Conway Planning Commission Staff Report

7:00pm • July 15, 2019 • 810 Parkway Avenue

I.A REQUEST FOR PRELIMINARY PLAT APPROVAL - 5TH AVENUE REPLAT

CITY OF CONWAY PLANNING & DEVELOPMENT DEPARTMENT 5TH AVENUE REPLAT

PRELIMINARY LOT PLAN

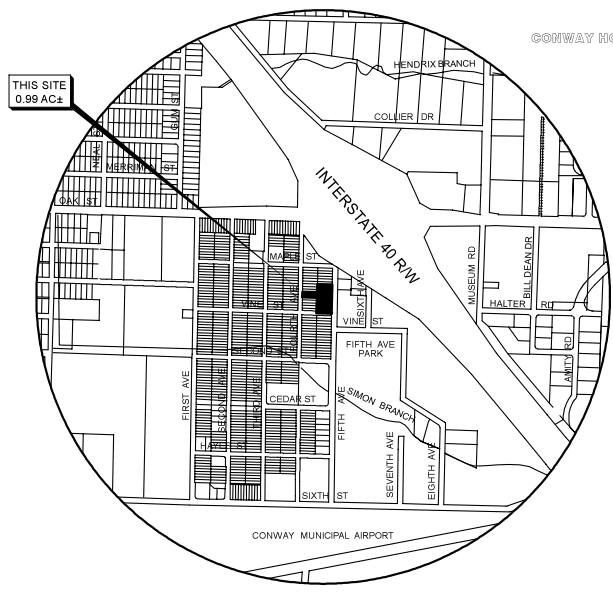
CORRECTIONS NEEDED ON THE PLAT

1. Show all hydrant locations.
2. Corrections as noted on Preliminary Plat.

Planning Staff recommends approval of the preliminary plat contingent upon the completion of the amended punch list and associated conditions of approval. The proposed lot sizes and frontage widths are consistent with the requirements of the R-2 zoning district.

1. Preliminary Plat approval from all reviewing agencies shall be obtained.
2. A draft of any Bill of Assurance proposed for the subdivision generally describing proposed covenants, restrictions and conditions applicable to the property included in the submitted plat.
3. Fire hydrants must be placed so that the furthest point of a lot in a residential subdivision is no more than 600 feet from the hydrant located on the same street. Variances must be approved by the Planning Commission and Fire Chief.
4. Minimum clearance of twenty-six (26) feet must be provided around a fire hydrant.
5. Utility easements as required by Conway Corporation are needed.
6. Drainage easements as required by the City Engineer are needed. (p. 33)
7. All other applicable provisions of the City of Conway Subdivision Ordinance (O-00-03) shall be satisfied and accounted for prior to Preliminary Plat approval.
